NUCLEAR REGULATORY COMMISSION

Title: Advisory Committee on Reactor Safeguards
 Regulatory Policies and Practices

Date: Thursday, May 19, 2016

Figure 3-14: Possible transitions in the 3-SV pressurizer pressure relief system considering both FTO and FTC valve conditions

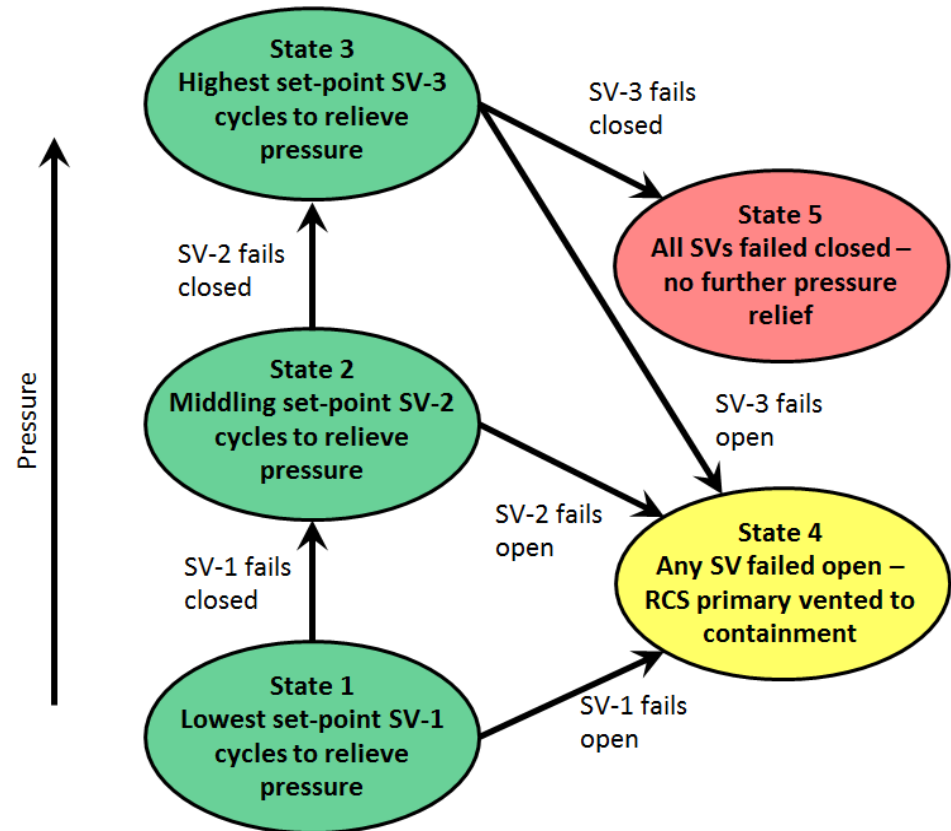
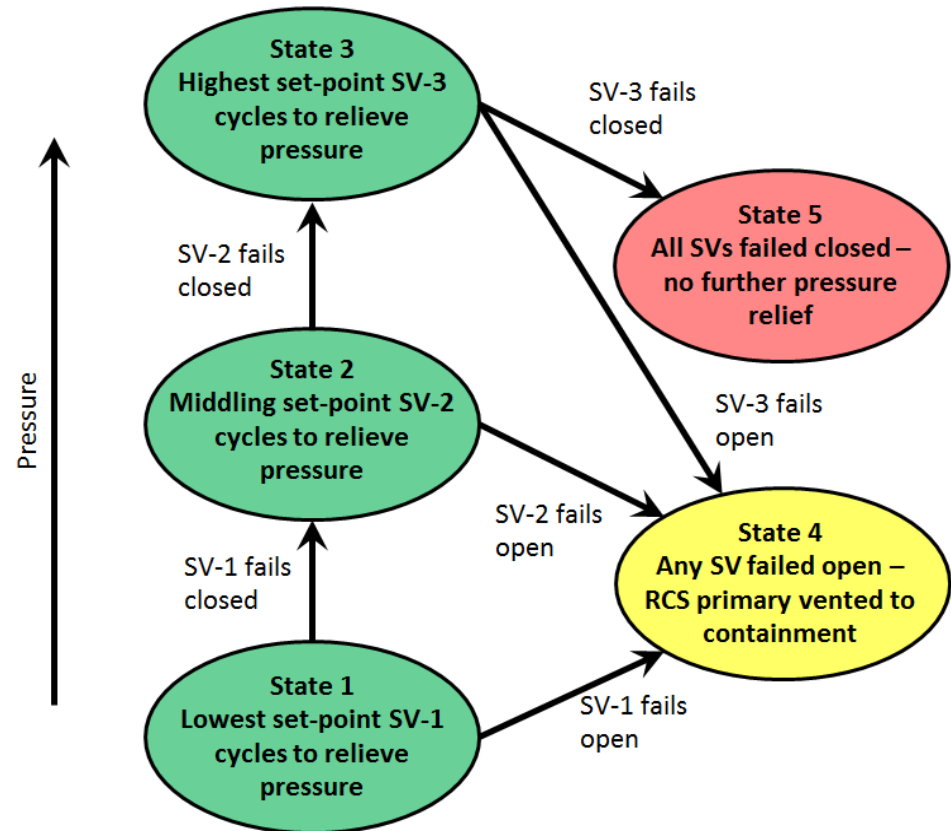
7 This diagram that you have here, as I
8 understand it these valves are modeled in MELCOR as
9 if they are completely independent. Is that
10 correct?

17 That is not correct because if we
18 account for -- this is a state of the art
19 uncertainty analysis, and state of the art
20 uncertainty analyses say that I have the common
21 state of knowledge regarding all three of those
22 valves such that if the world works according to
23 sample 1 from my model of the world then all three
24 valves work the same way.

8 CHAIRMAN STETKAR: That is what you did
9 or your tables are wrong because you have summary
10 tables that show me three separate --

14 But this time we tried to add that
15 aleatory aspect, the random nature of you don't
16 actually know given that failure rate which demand
17 number that valve will actually fail at.

Failed Ice Condenser Door Open Area Fraction

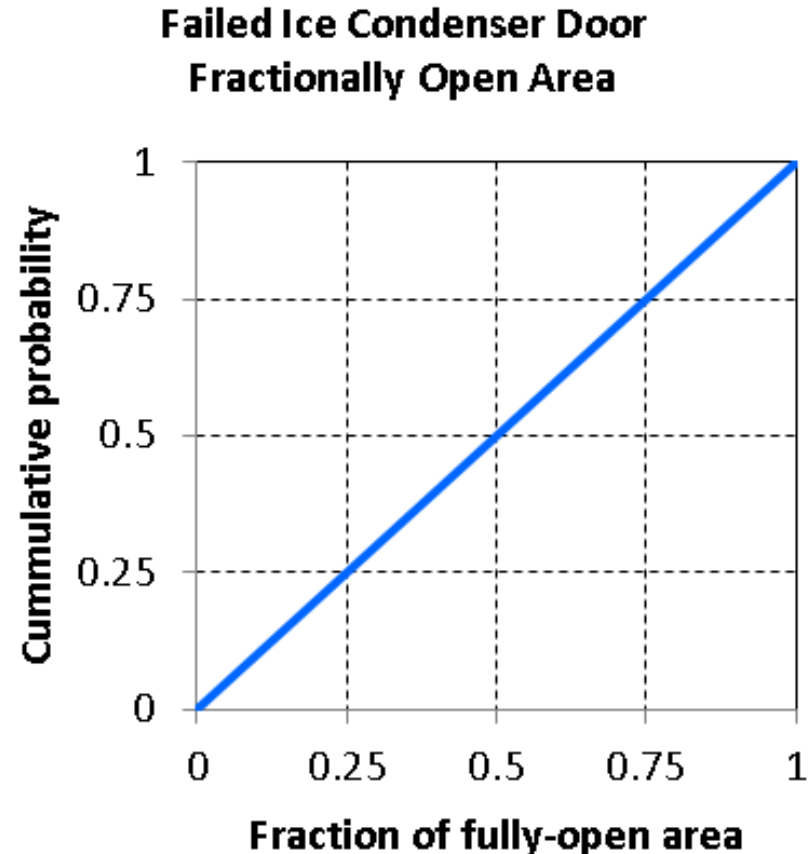
1 suppose they all did stick open the first time you
2 get up to whatever that pressure that opens them
3 fully. How would the results of the study change?

9 MR. ESMAILI: And so we will have to do
10 sensitivity. The question will have come up and
11 saying, you know, you have to do sensitivity
12 calculation to show what if they don't open.
13 Because in that same NUREG they're saying that it
14 is possible that these doors could be reversible.
